**REQUEST FOR WAIVER FROM ACCESSIBILITY REQUIREMENTS
OF CHAPTER 553, PART V, FLORIDA STATUTES**

Name: Miami Art Museum

The City of Miami Building Department has indicated in their review of the plans that the proposed auditorium does not meet the requirement for vertical accessibility to all levels.

1: Florida Building Code Section 11-4.1.3

1 AUDITORIUM ENLARGED PLAN
Scale: 1/4"=1'-0"
AUDITORIUM PLAN
DRAWING NUMBER
A-620

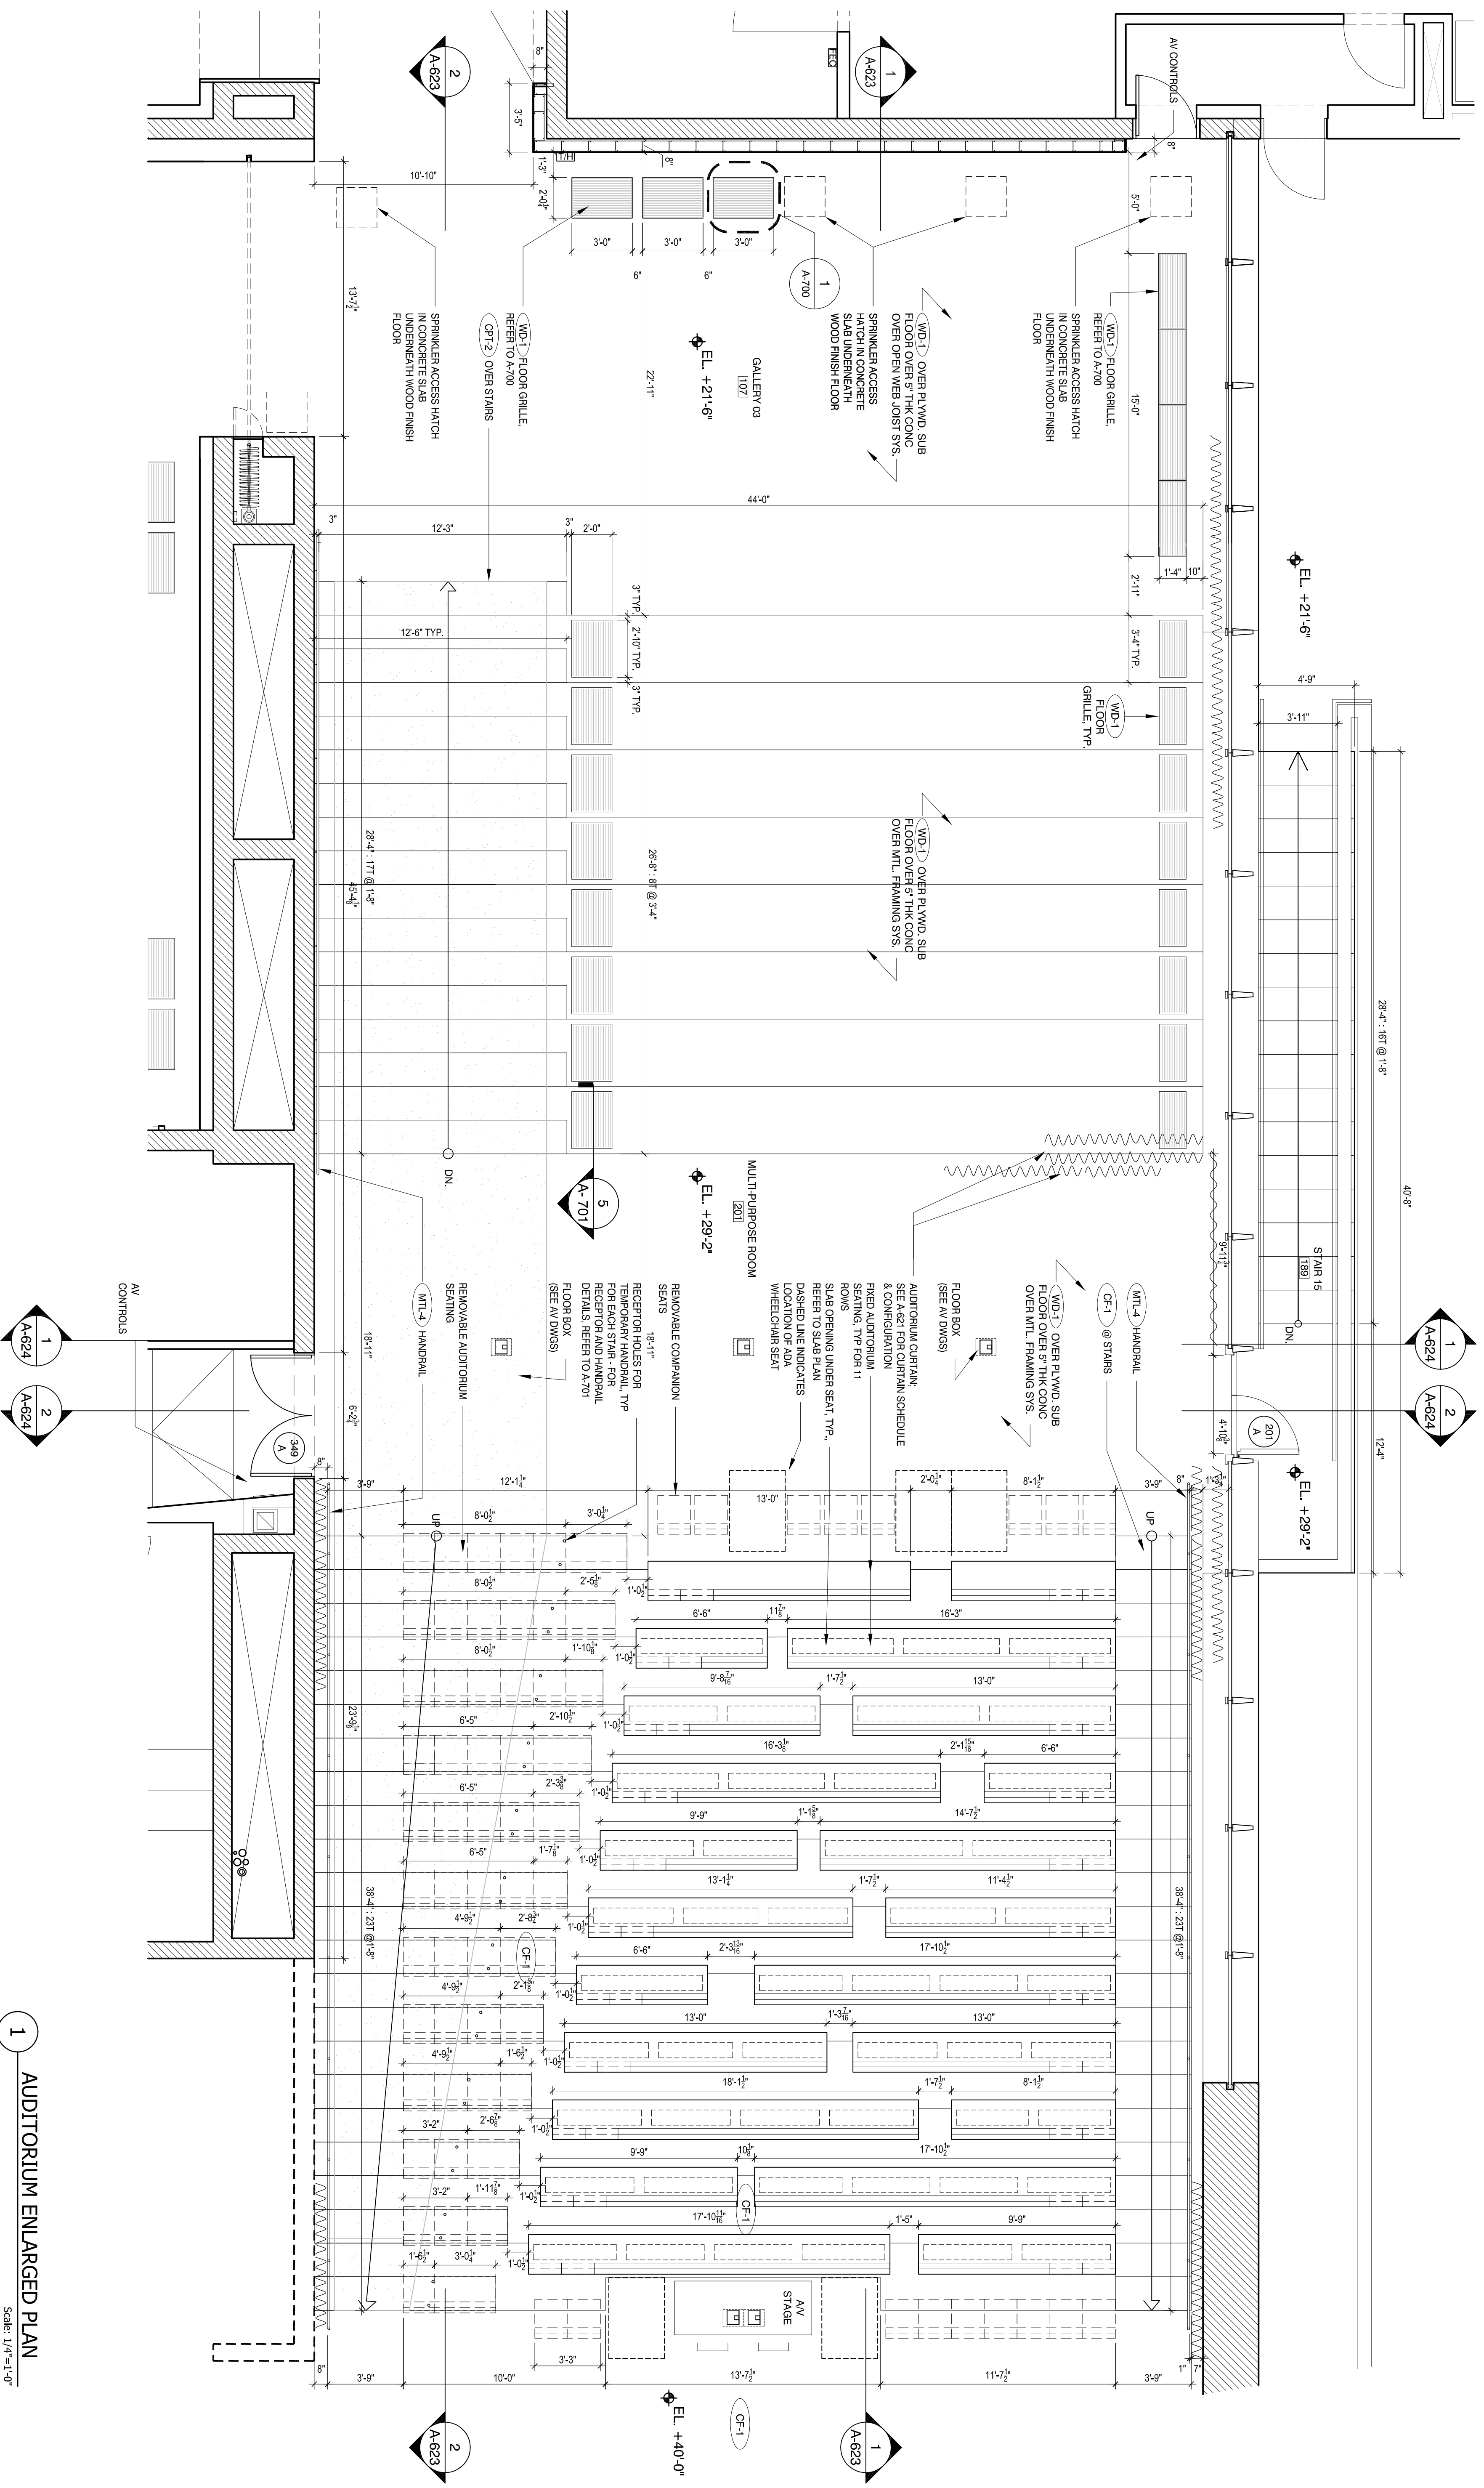
Providing accessibility to all levels of the auditorium seating would require a series of ramps extending perpendicular to the rows of seating thereby increasing the width of the auditorium space by approximately 50%. The cost of such an increase would be a hardship to an art museum for which the auditorium is a secondary function.

Vertical accessibility is not being provided to every individual row within the 249-seat auditorium. Vertical accessibility will be provided to the top and bottom rows and will meet the requirements for accessibility under FBC Section 11-4.33 Assembly Areas, including number and location of designated wheelchair areas and associated companion seats.

Comments/Recommendation Approval as submitted
